Re: **LETTER OF TRANSMITTAL  
ROOMS TO GO STORE EXPANSION AND REMODEL  
18722 South Dixie Highway  
Cutler Bay, FL 33157  
POST BID ADDENDUM #5**

## **POST BID ADDENDUM NO. FIVE**

Incorporate the following revised CASCO drawings dated 01/29/2024, with revisions including, but not necessarily limited to, those listed below:

ADULT SALES  
INTERIOR  
ELEVATIONS  
AND DETAILS  
A6.3

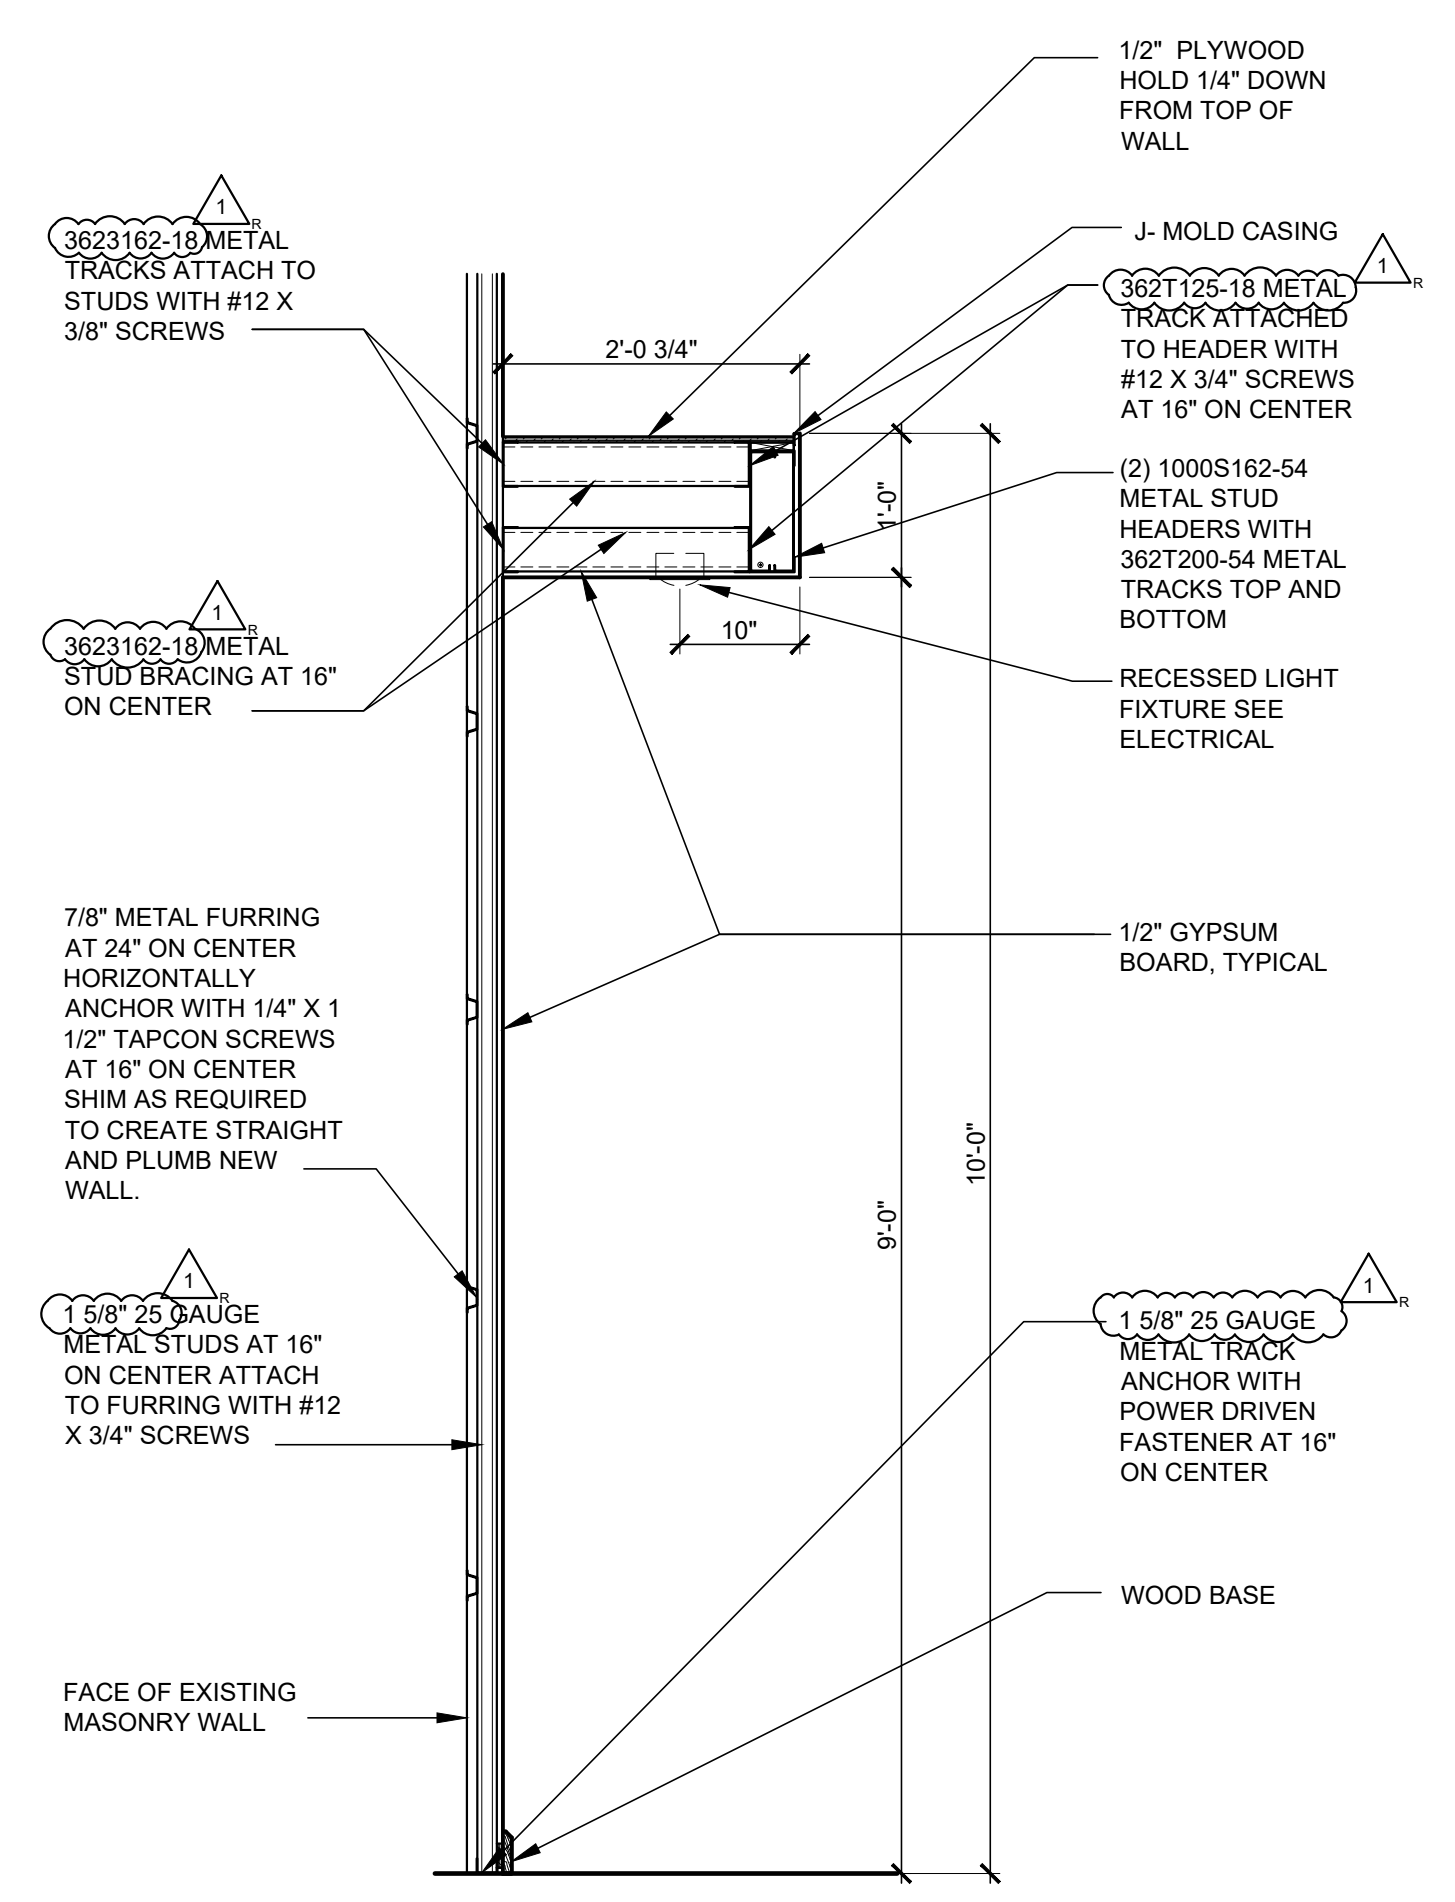
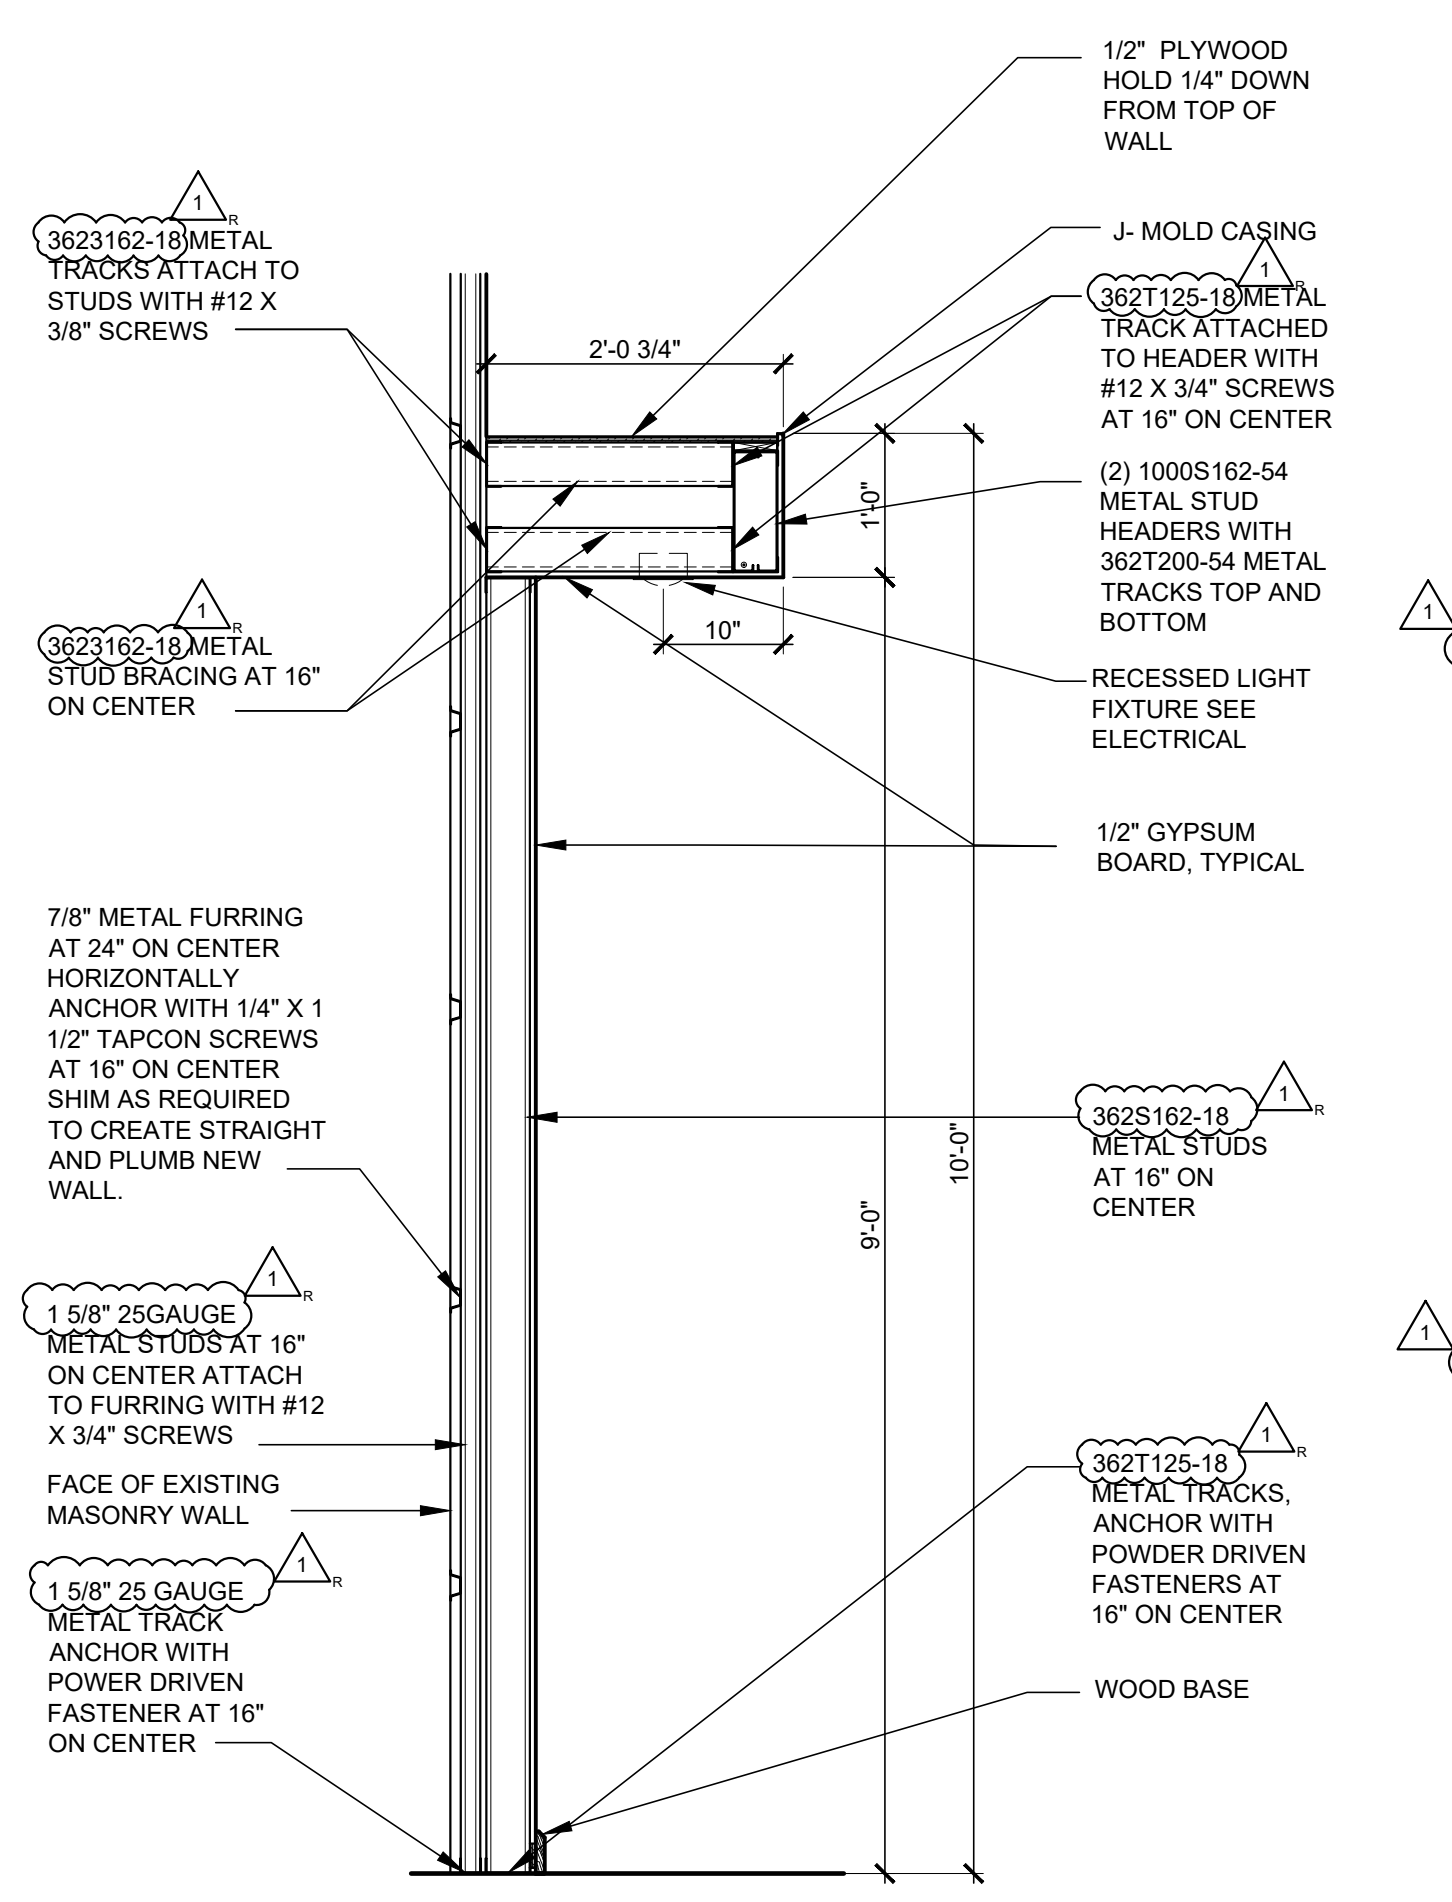
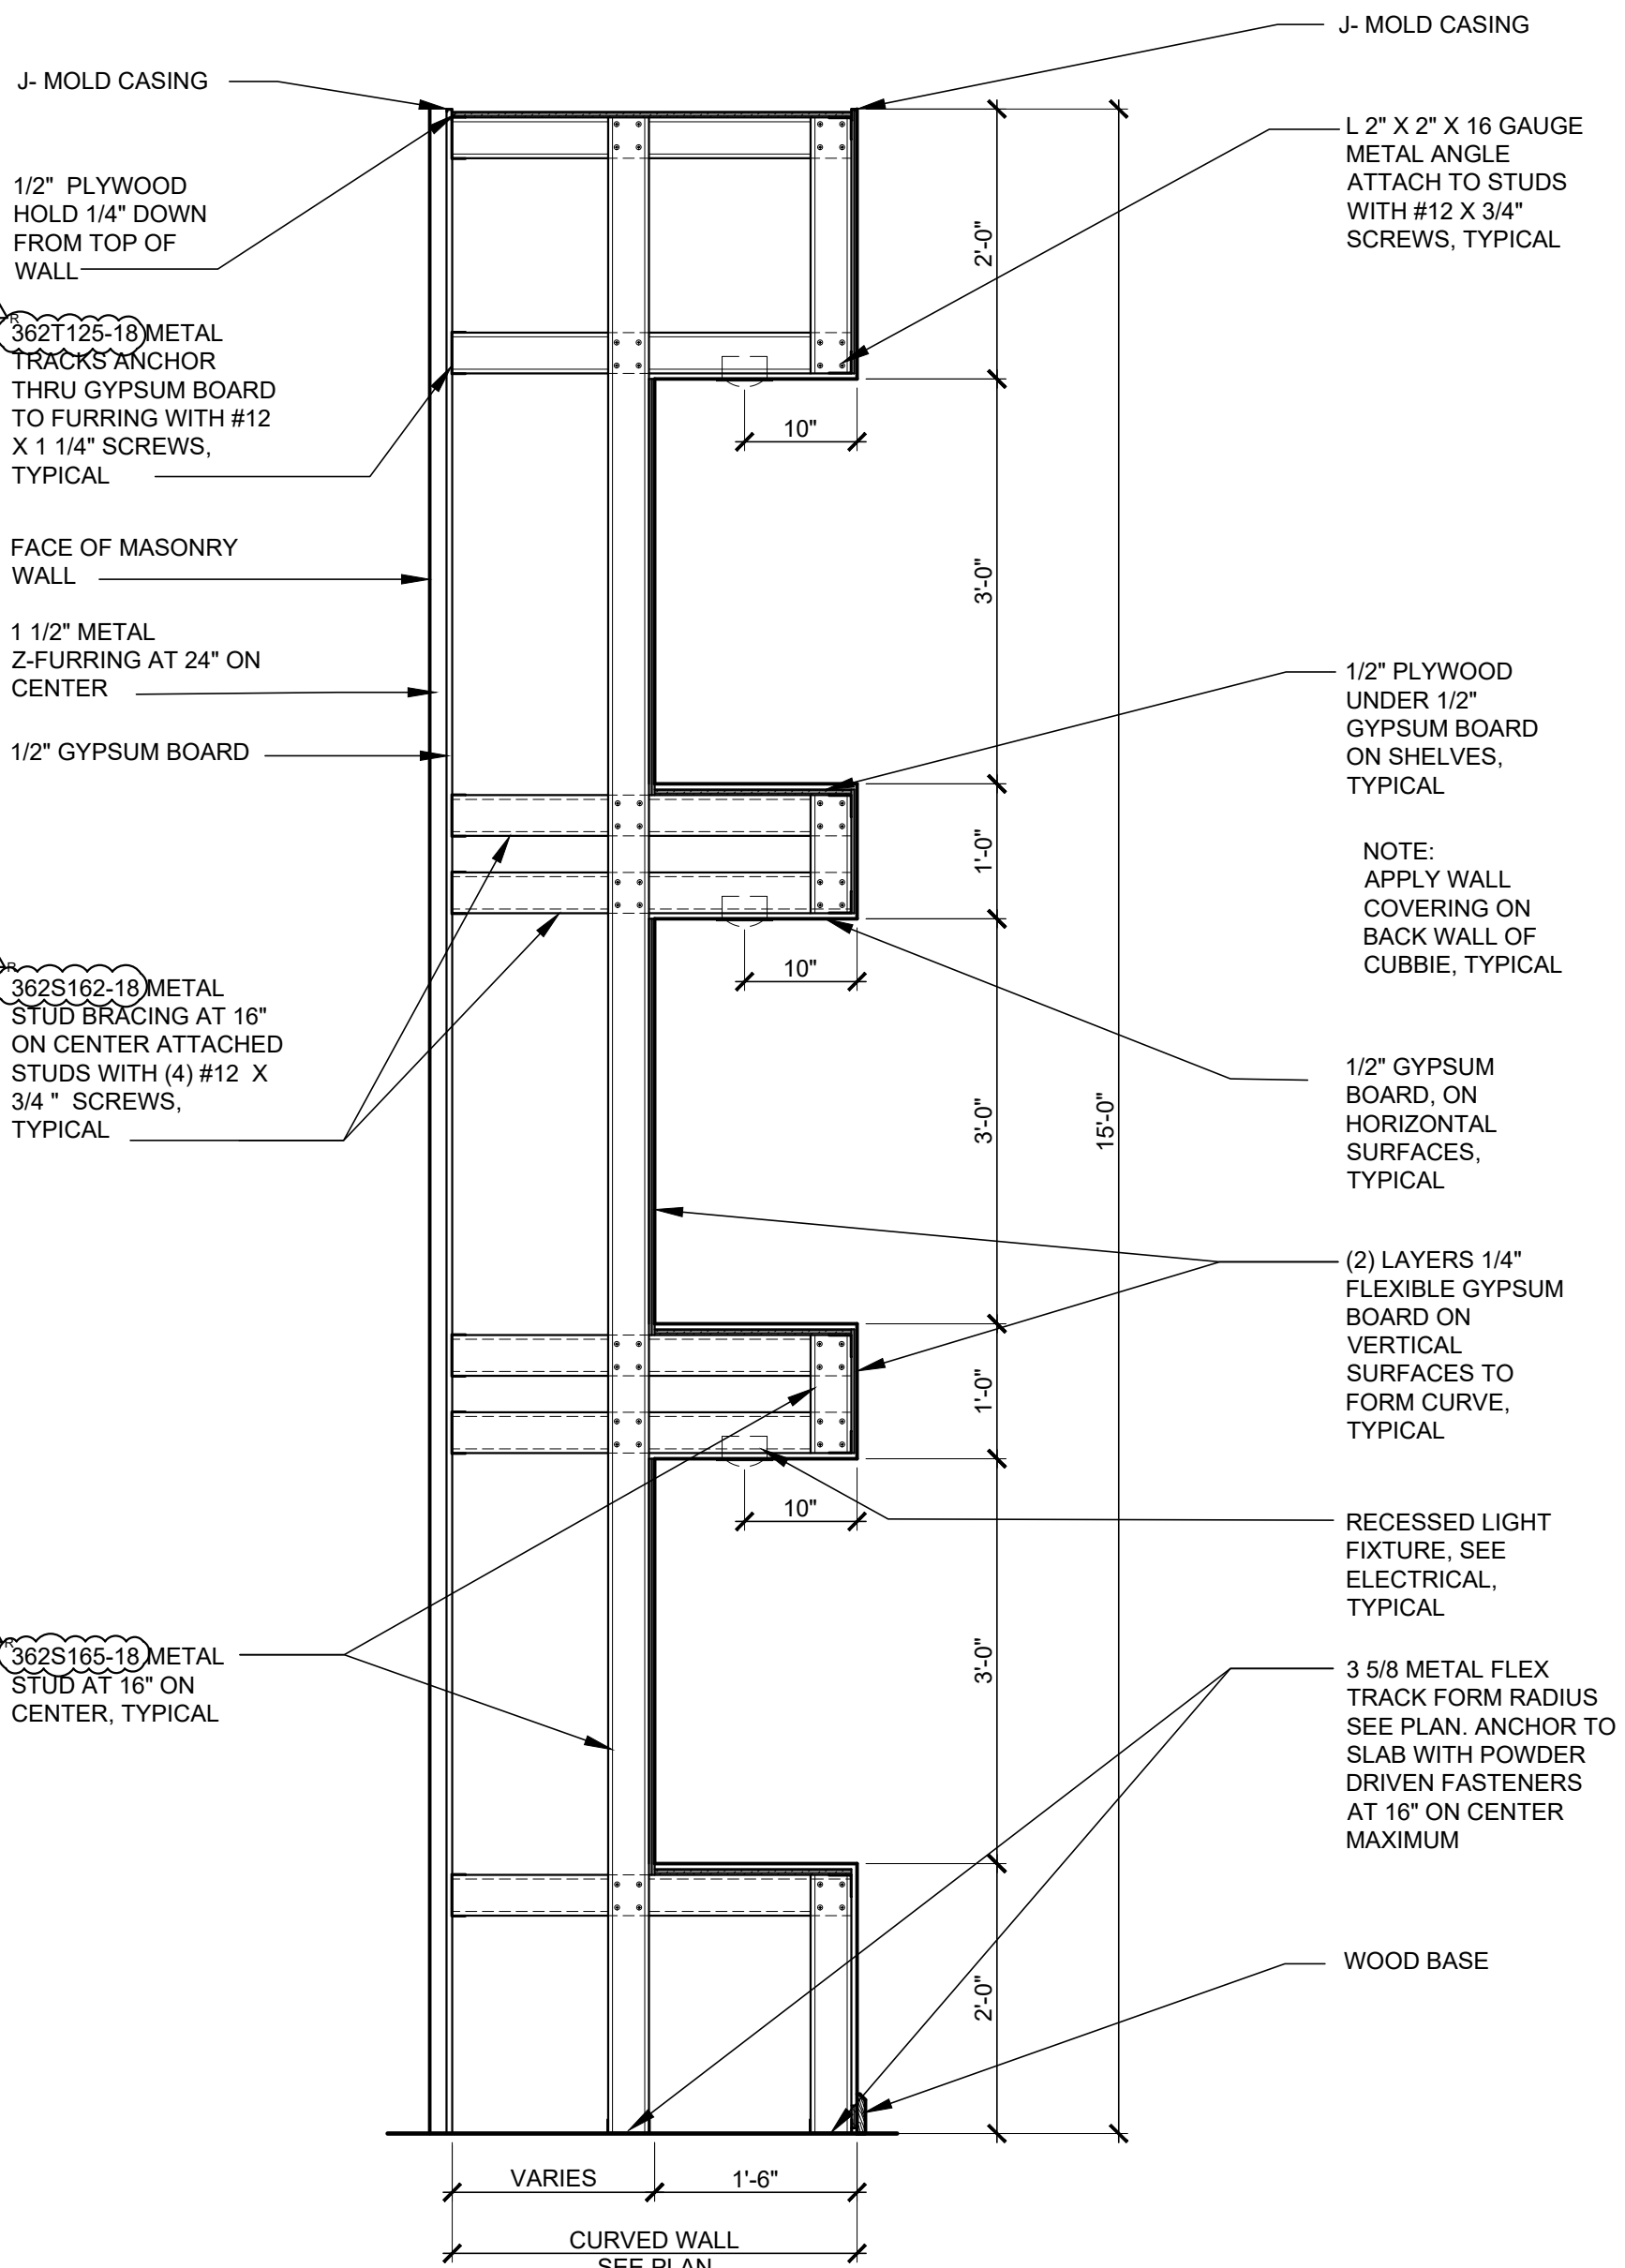
18. Sheet A6.3 – Revision No. 1: Revised Elevations “R2”, “T”, “U”, “V”. Revised Detail 4/A6.3. Revised 362S162-33 metal studs to 362S163-18 metal studs. Added Detail #7/A6.3.
